PIC18F2410/2510/4410/4510 Rev. A1 Silicon Errata

The PIC18F2410/2510/4410/4510 Rev. A1 parts you have received conform functionally to the Device Data Sheet (DS39636D), except for the anomalies described below. Any Data Sheet Clarification issues related to the PIC18F2410/2510/4410/4510 will be reported in a separate Data Sheet errata. Please check the Microchip web site for any existing issues.

The following silicon errata apply only to PIC18F2410/2510/4410/4510 devices with these Device/Revision IDs:

FIGURE 1: SCK PULSE VARIATION USING TIMER2/2

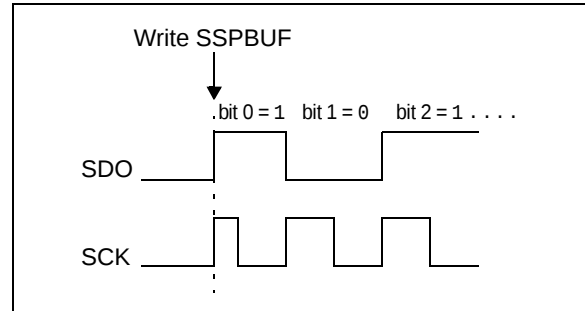
When the SPI is using Timer2/2 as the clock source, a shorter than expected SCK pulse may occur on the first bit of the transmitted/received data (Figure 1).

To avoid producing the short pulse, turn off Timer2 and clear the TMR2 register, load the SSPBUF with the data to transmit and then turn Timer2 back on. Refer to Example 6 for sample code.
